WATER RESOURCES DEPARTMENT

PUBLIC INTEREST REVIEW FOR GROUNDWATER APPLICATIONS

SUBJECT: Application G- 18278 Supersedes review of NA
Date of Review(s)

A. GENERAL INFORMATION: Applicant's Name: Roy Miller County: Harney

Water-Level Trends in Nearby Wells

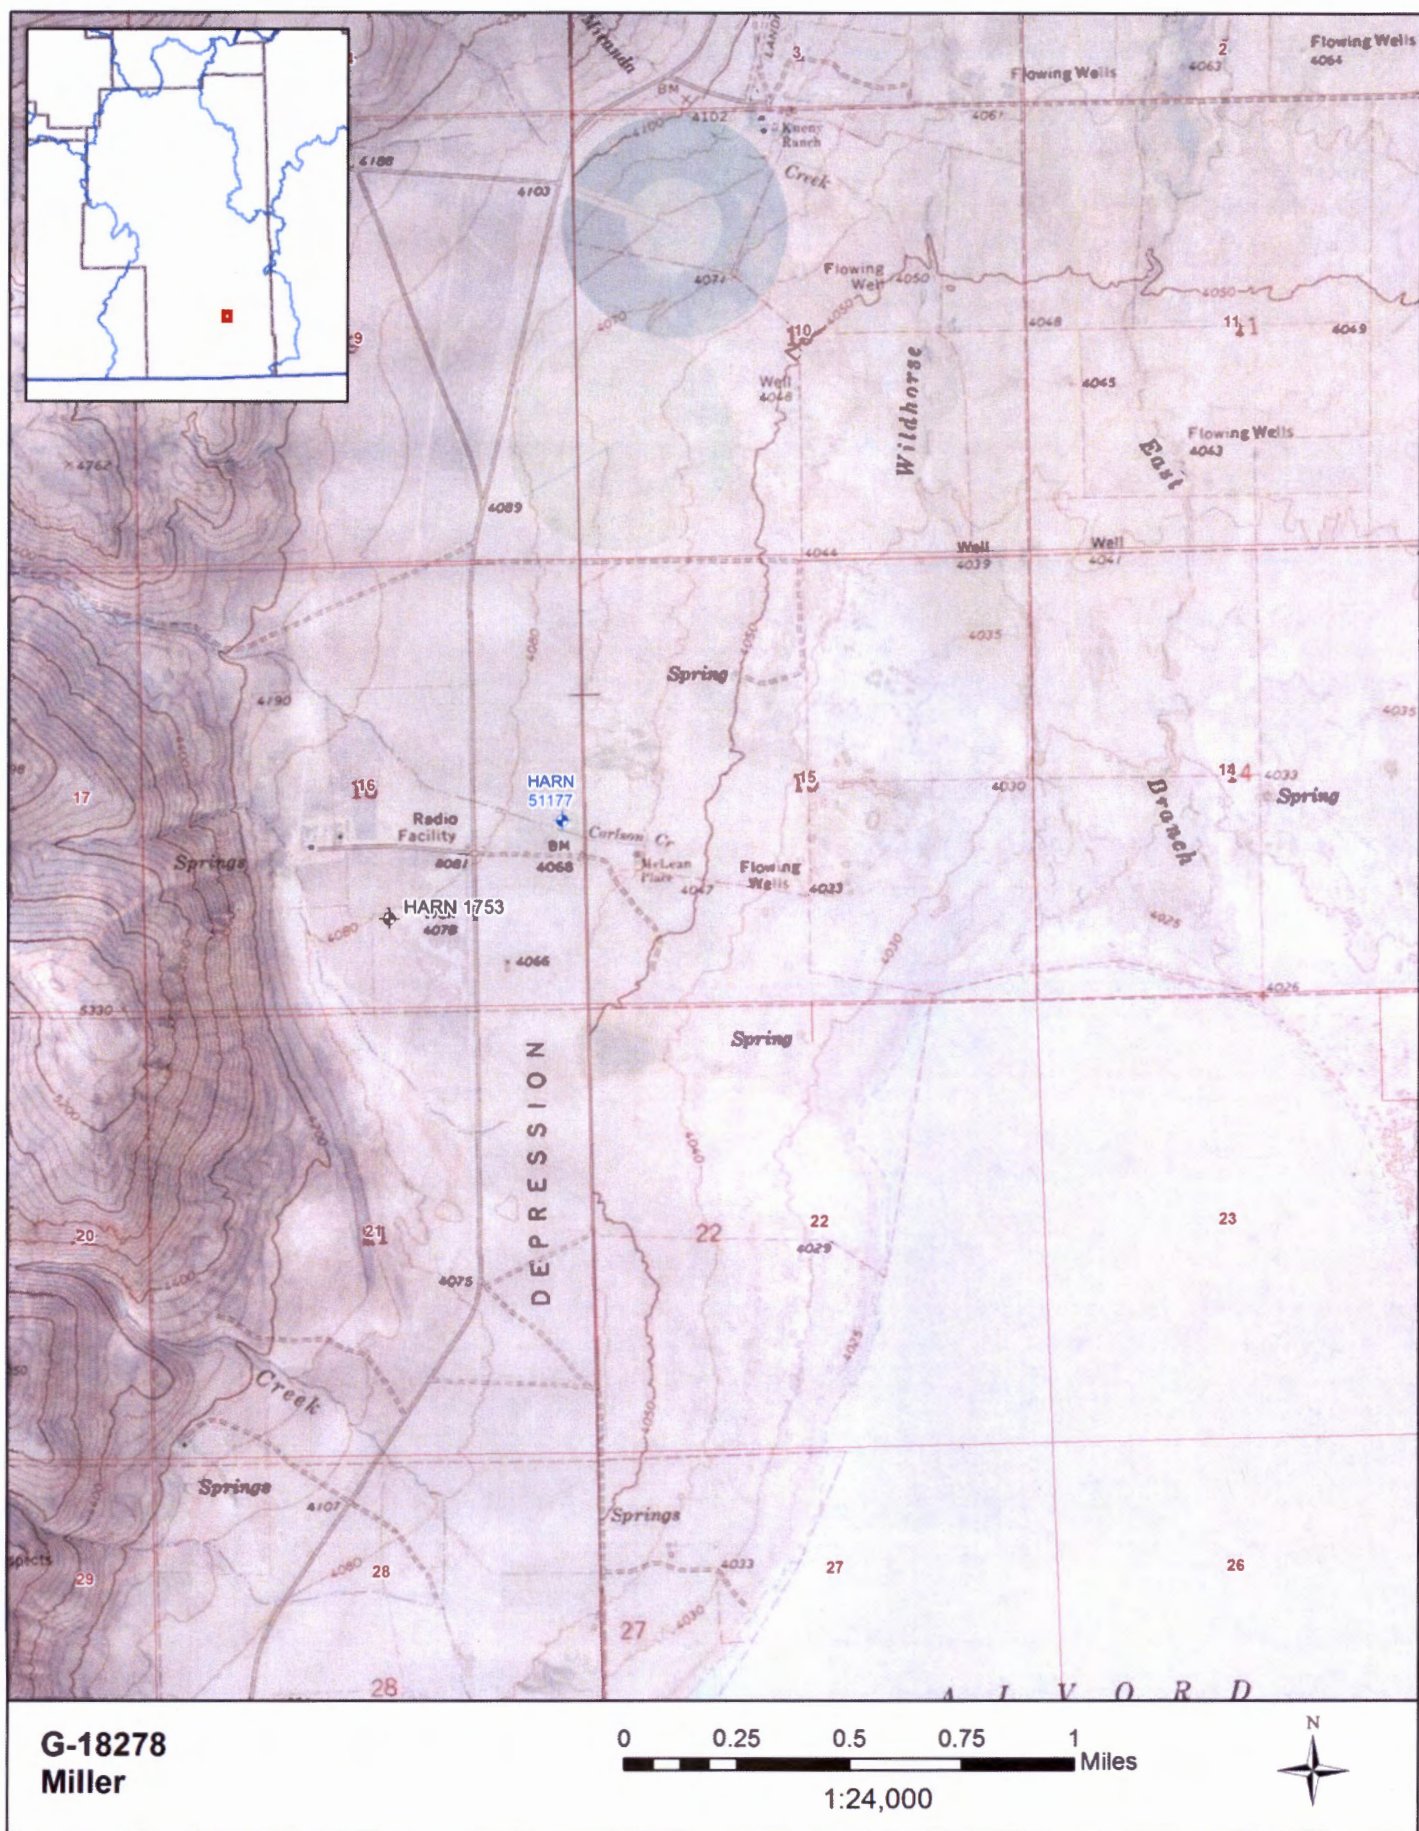
State observation well 193 (HARN 1753) is located ~0.4 miles southwest of the proposed well and has a period of record from 1969 to the present. The hydrograph for this well (see attached) shows an increase in seasonal drawdown since about 2010, but there is insufficient data to substantiate long term year to year water level declines at this time.
